DATE ~~R~~ Aug.10/01**V2500-A5/D5 PROPULSION SYSTEMS SERVICE BULLETIN**

This document transmits Revision 5 to Service Bulletin EV2500-73-0094

To correct effectivity and  
 engine serial numbers, add  
 ATA locator and internal  
 reference numbers.

ENGINE – FUEL AND CONTROL – REROUTE THE LEFT AND RIGHT PRESSURE CONTROL TUBE  
ASSEMBLIES

Installation of the P4.9 manifolds  
Fig 2 (sheet 1)

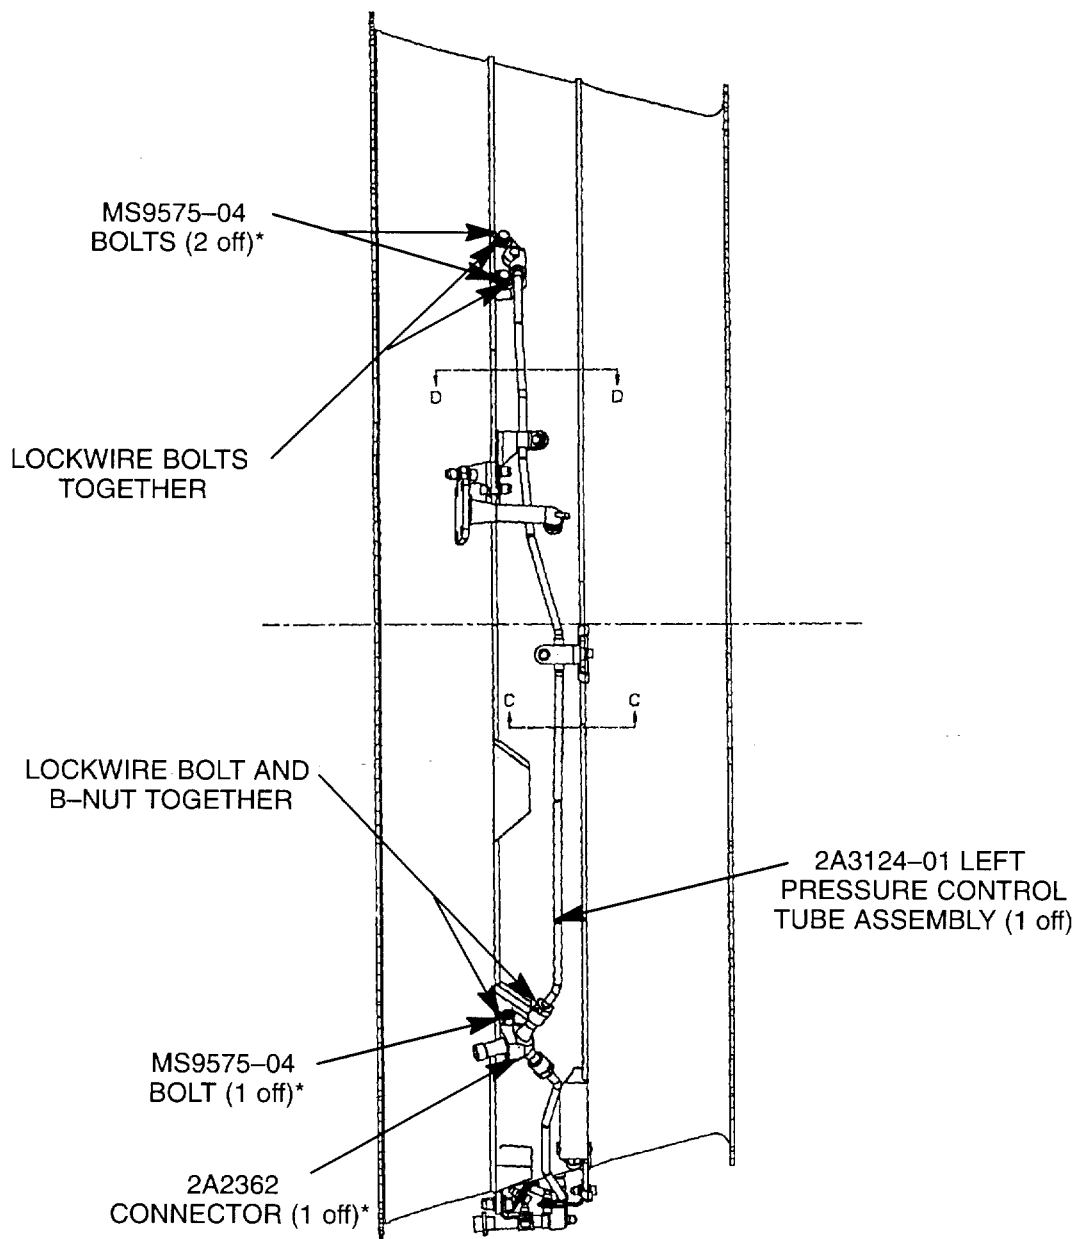
- (1) Condition: There is a possibility of interference between the P4.9 manifolds and the nacelle thrust reverser heatshields that can lead to contact wear of the manifolds.
- (2) Background: The shape of the P4.9 Manifold Assemblies can cause contact between the Manifolds and the Nacelle Thrust Reverser Heatshields in some situations. There have been several reports of manifold wear in service run engines.
- (3) Objective: Revise the shape of the P4.9 Manifold Tube Assemblies to eliminate the possibility of interference between it and the thrust reverser heatshields.
- (4) Substantiation: The Manifold Assemblies were successfully installed and operated on flight test aircraft.
- (5) Effect of Bulletin on:
- Removal/Installation: Not affected.
- Disassembly/Assembly: Not affected.

Install a new set of P4.9 Manifold Assemblies.

Installation of the P4.9 manifolds  
Fig 2 (sheet 2)

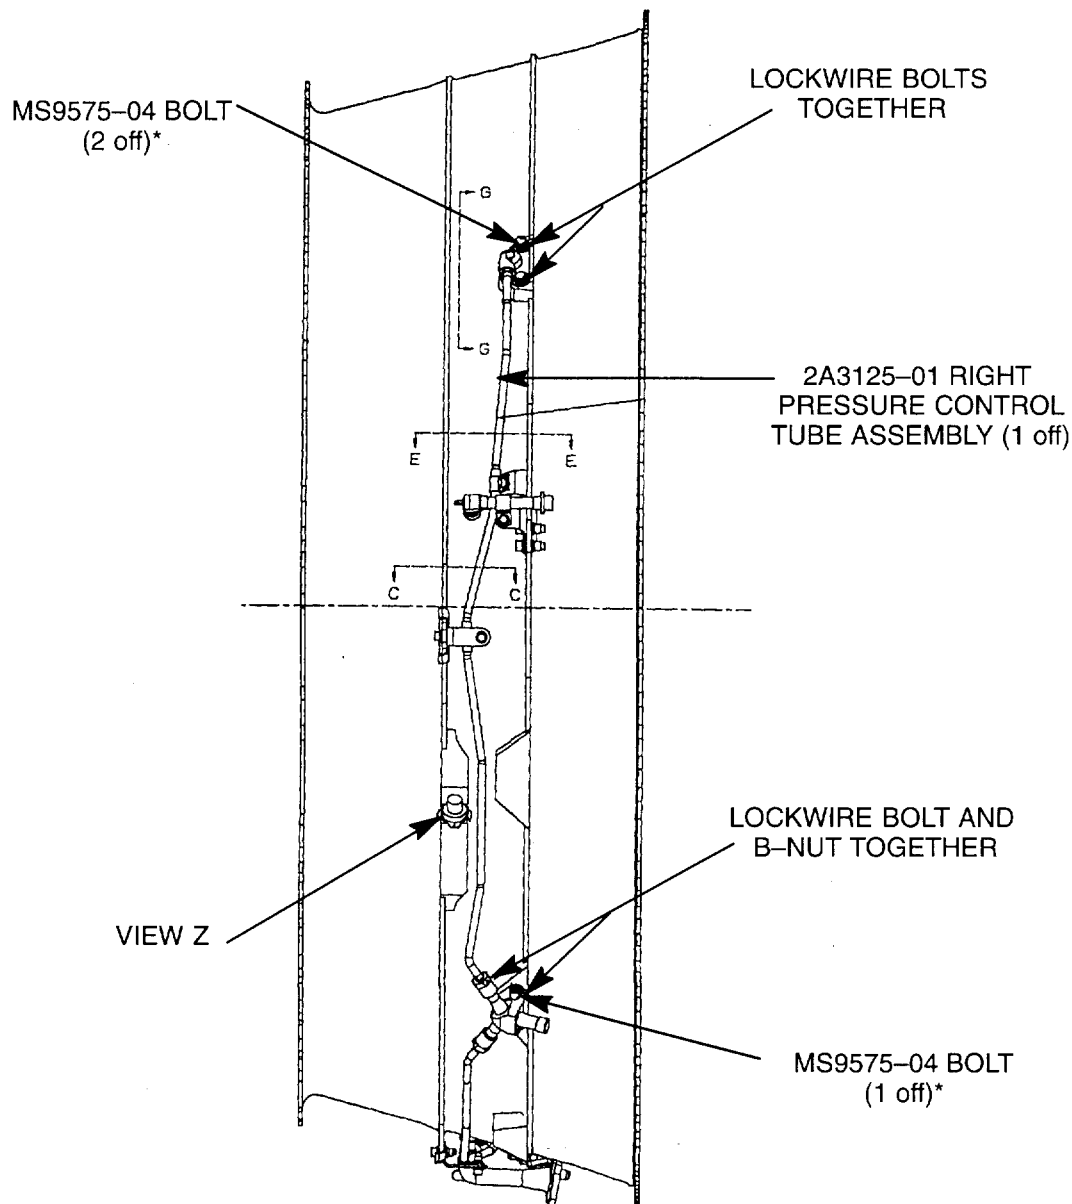
(iii) Install the 2A3119 Loop Clamp Brackets (2 off) at the locations given in (View C-C) Figure 2 (Sheets 2 through 4).

Installation of the P4.9 manifolds  
Fig 2 (sheet 3)

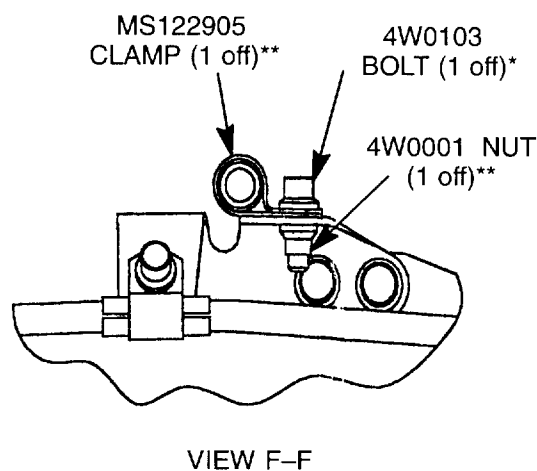
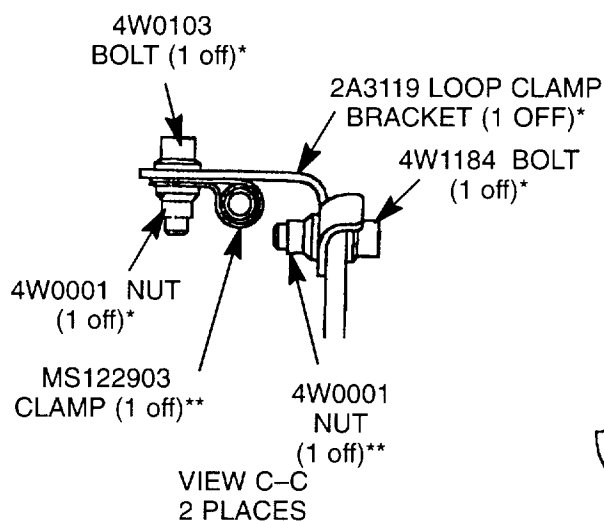
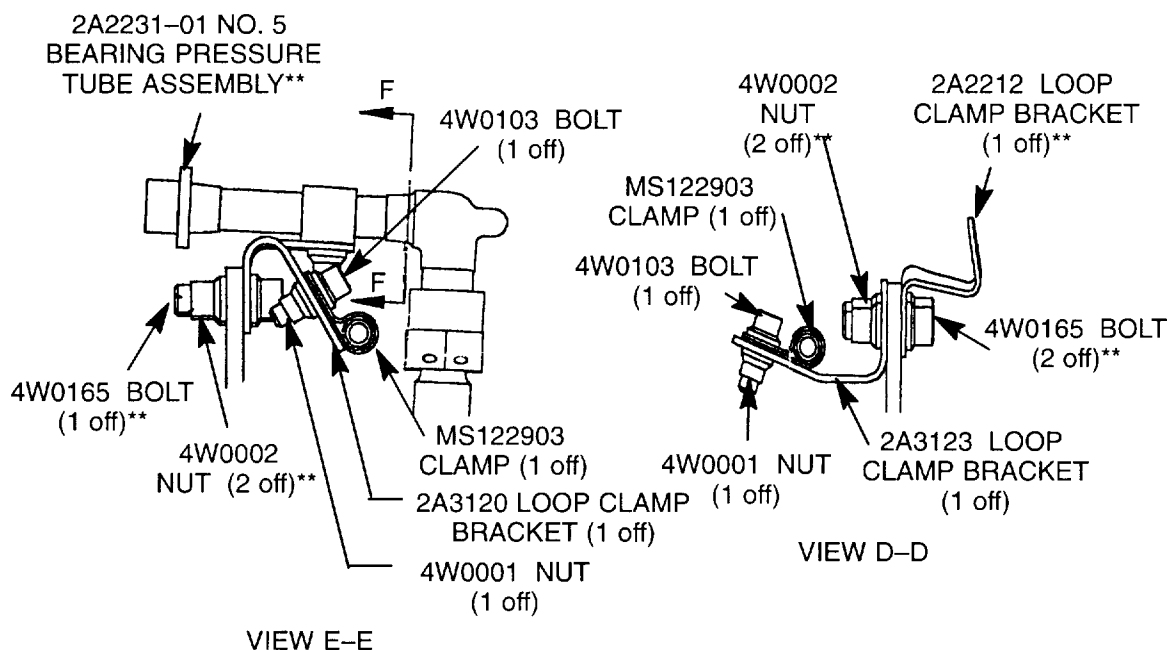
(a) Disconnect the 6A5023 Oil Weep Tube Assembly as necessary to replace the MS9514-19 Washer with the 2A3127 Saddle Washer. See Figure 2 (Sheets 3 and 5).

- (v) Replace the MS9549-14 Washer with the 2A3127 Saddle Washer at the location shown in (View Z) Figure 2, (Sheets 3 and 5).
- (vi) Connect the tube nut to the turbine case connector.

Installation of the P4.9 manifolds  
Fig 2 (sheet 4)

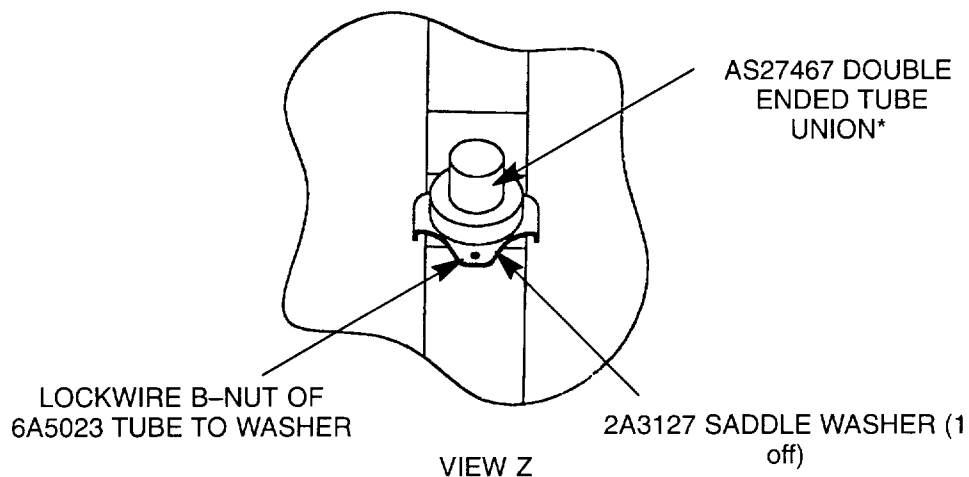
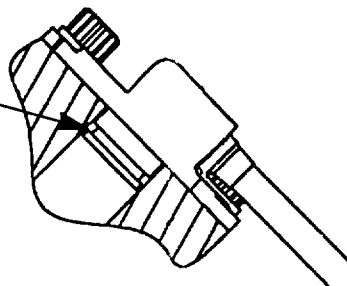
(i) Install the 2A3120 Loop Clamp Bracket (1 off) at the location shown (View E-E) in Figure 2, Sheet 4.

(ii) When you install the 2A2212 Bracket, (View D-D) in Figure 2 (Sheet 4), install the 2A3123 Loop Clamp Bracket (1 off), the MS122903 Clamp (1 off), the 4W0103 Bolt (1 off) and the 4W0001 Nut (1 off).
